Administrative Approval Action

Case File / Name: ASR-0025-2022 DSLC - 6224 Angus Drive (ASR) City of Raleigh
Development Services Department
One Exchange Plaza
Raleigh, NC 27602
(919) 996-2492
currentplanning@raleighnc.gov
www.raleighnc.gov

REQUEST: Development of a vacant 1.33-acre tract zoned IX-3-PK AOD, with .02acres/687 sf

of right-of-way dedication, leaving a net area of 1.31 acres/57,461 sf. A proposed 10,890 GFA Warehouse & Distribution building, containing 7 units (1,440 sf/unit).

LS-1.0

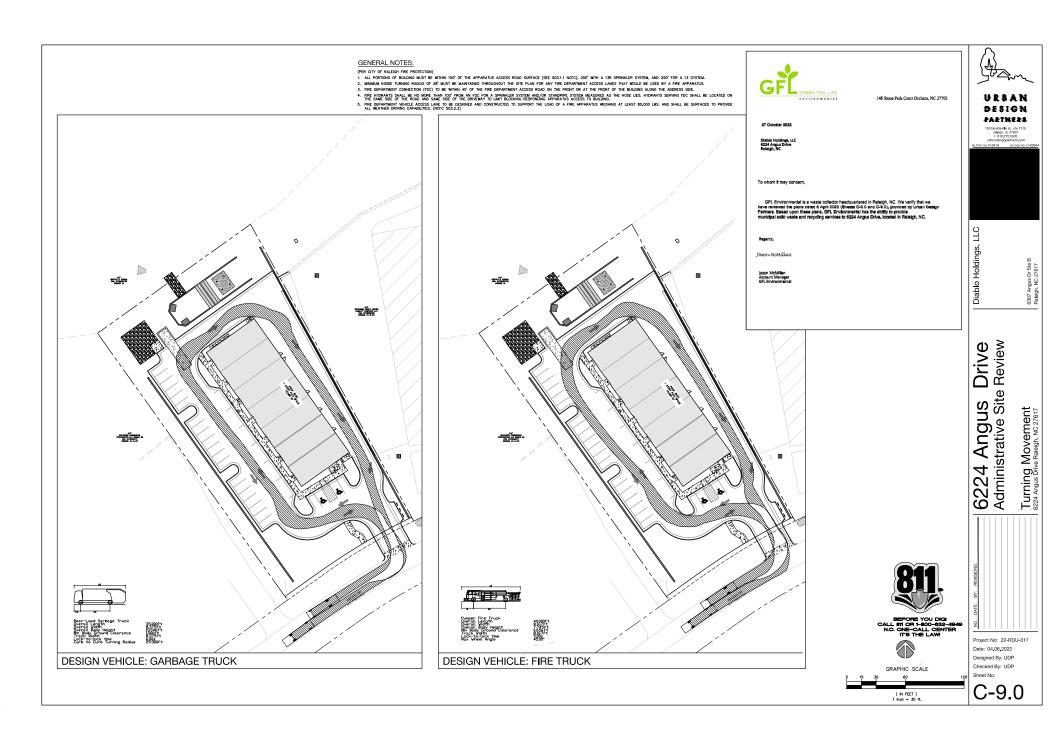
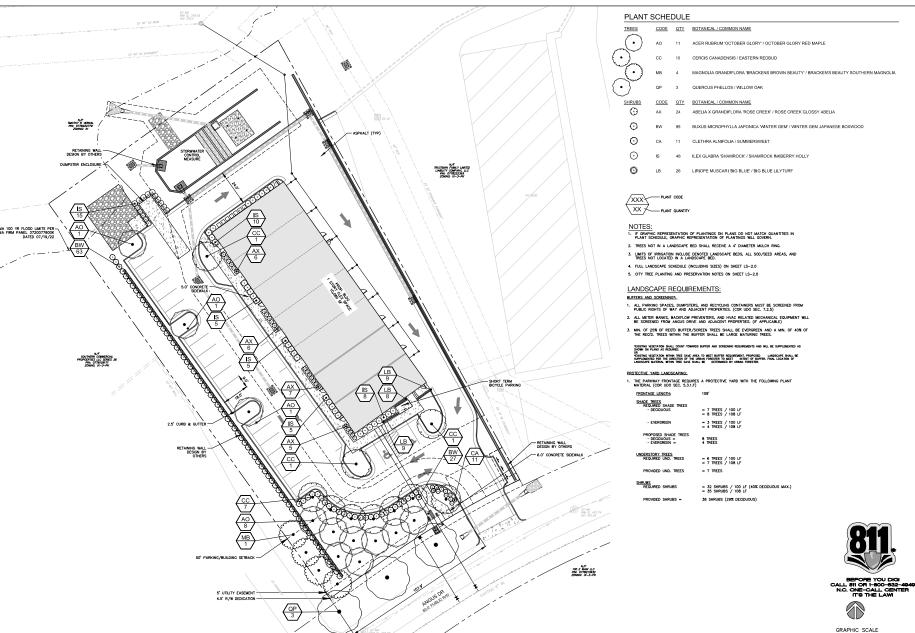
- 1. Revise and show zoning as IX-3-PK AOD.
- 2. Landscaping sheet LS-1, the planting schedule table is amended, and note which of the proposed shade and understory trees are 'evergreen' & 'deciduous' per the annotation and proposed plantin
- 3. All proposed retaining walls demonstrate compliance with design, length, and height requirements per UDO Sec.7.2.8.B.D.
- 4. All proposed lighting fixtures design and building lighting comply with and demonstrate design requirements per UDO Sec.7.4.4, Sec.7.4.5, Sec.7.4.10, and Sec.7.1.7.G.
- 5. The Parkway (-PK) Frontage design requirements are all listed on the data table, including the pedestrian access easement width, on sheet C3, per UDO Sec.3.4.3.D.D3.
